Minute No. 595

Report – Standing Policy Committee on Property and Development, Heritage and Downtown Development – July 6, 2021

**Item No. 11 Subdivision and Rezoning – Southeast Corner of Gunn Road and Redonda Street
(Transcona Ward)
File DASZ 19/2020 [c/r SPA 4/2020 and DAC 5/2020]**

SCHEDULE "C," SIDEWALKS AND PATHS, June 20, 2021

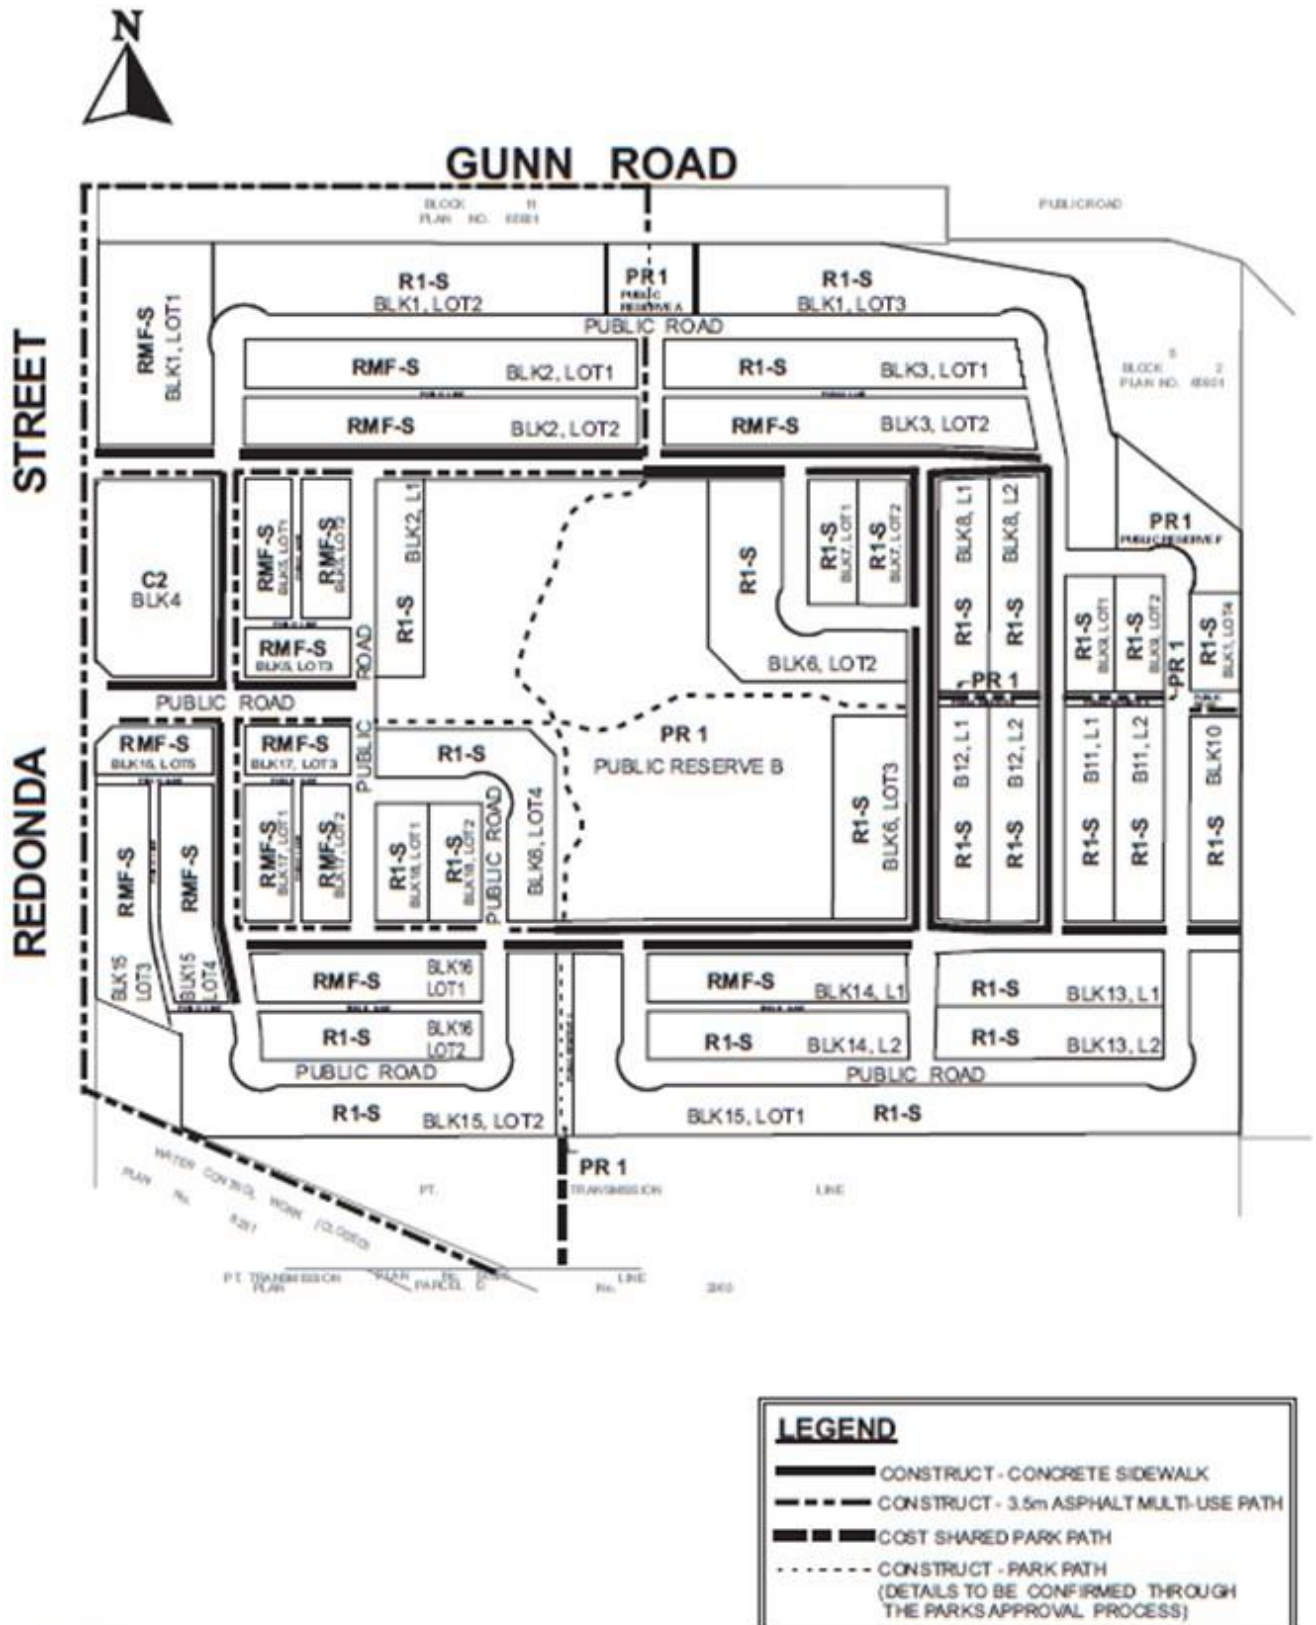
- vi. Amend Condition 3) a) under ‘Section IV – Servicing Conditions’ by adding the word “revised” immediately before “Schedule C”
- vii. Delete condition 5) d) under ‘Section IV – Servicing Conditions’

- vi. Amend Condition 3) a) under ‘Section IV – Servicing Conditions’ by adding the word “revised” immediately before “Schedule C”
- vii. Delete condition 5) d) under ‘Section IV – Servicing Conditions’

- vi. *Amend Condition 3) a) under ‘Section IV – Servicing Conditions’ by adding the word “revised” immediately before “Schedule C”*
